**MISSILE ANALYSIS METHODOLOGY FOR GE NUCLEAR STEAM TURBINE ROTORS BY
THE SWPC**

**THE NUCLEAR REGULATORY COMMISSION AS TOPICAL REPORT TP-03143-NP-A
FOR PUBLIC RECORD**

SUBJECT: SAFETY EVALUATION FOR ACCEPTANCE OF REFERENCING THE
SIEMENS WESTINGHOUSE TOPICAL REPORT, "MISSILE ANALYSIS
METHODOLOGY FOR GENERAL ELECTRIC (GE) NUCLEAR STEAM
TURBINE ROTORS BY THE SIEMENS WESTINGHOUSE POWER
CORPORATION (SWPC)" (TAC NO. MB5679)

SAFETY EVALUATION BY THE OFFICE OF NUCLEAR REACTOR REGULATION

Figure 3.2 Toughness (K_{1c}) versus Excess Temperature

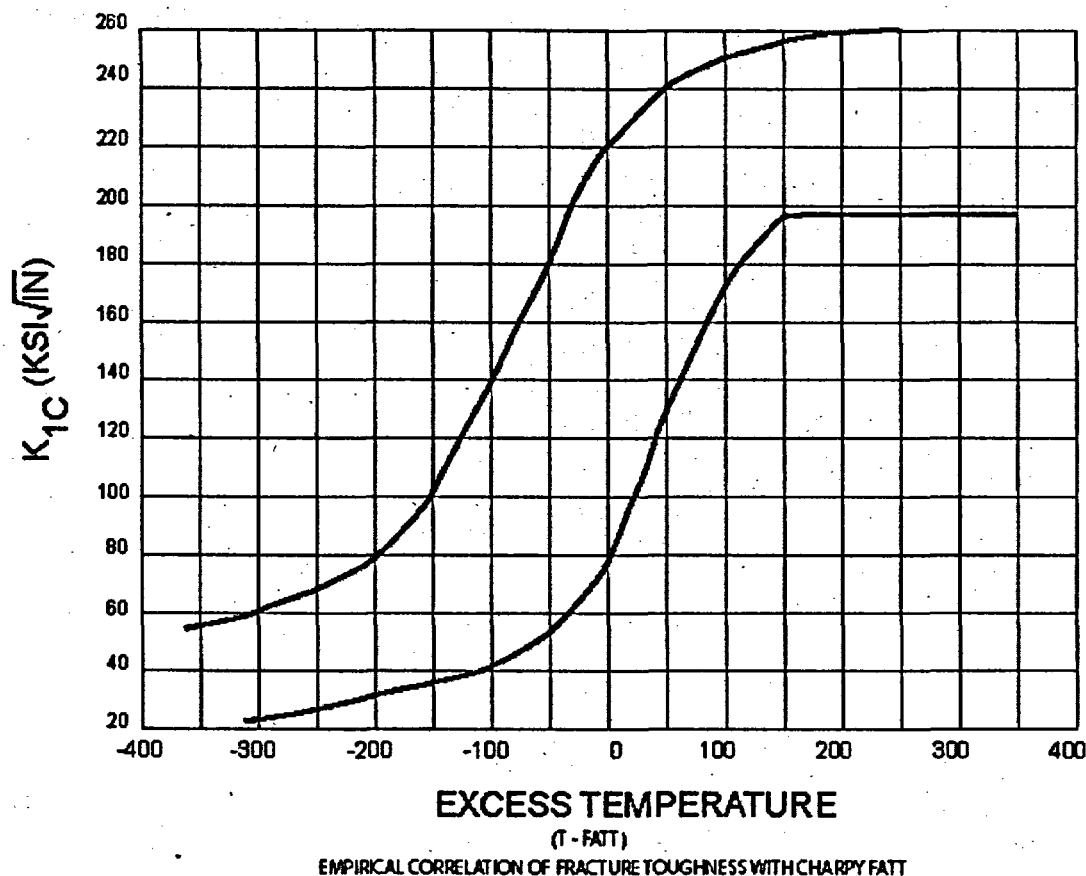
The NRC staff also questioned whether the standard deviation for K_{Ic} is large enough to account for the scatter and uncertainties associated with limited test data and whether a randomly selected K_{Ic} value used in the Monte-Carlo simulations might be unrealistically high. In response to this concern, SWPC decided to use [] percent of the mean K_{Ic} value as the standard deviation and use a value of [] ksi/in for the maximum upper-shelf mean K_{Ic} value in its disk burst analysis. The staff considers these values to be acceptable because the same standard deviation for K_{Ic} and the maximum upper-shelf mean K_{Ic} value has been used successfully in vessel probabilistic fracture mechanics (PFM) analyses for twenty years for similar types of steels.

Since fracture toughness (K_{Ic}) tests are not normally performed for turbine disks, the Westinghouse methodology obtained K_{Ic} values from measured Charpy V-notch (CVN) data and yield strength using the Rolfe-Barsom equation. Siemens also used this empirical equation to estimate K_{Ic} values for turbine disks in its proposed turbine missile methodology. In response to the NRC staff's concerns regarding the determination of K_{Ic} values using the Rolfe-Barsom equation, SWPC further clarified that the Siemens methodology will use the Rolfe-Barsom equation only for disks operating in the upper shelf region, and for disks operating below the upper shelf region, it will use a K_{Ic} and (T-FATT) correlation based on GE data, where FATT stands for the test-determined fracture appearance transition temperature. This procedure in determining the K_{Ic} values, which will be used as mean values in the subsequent Monte-Carlo simulations, is more rigorous than the previously approved ones, and is therefore acceptable to the NRC staff.
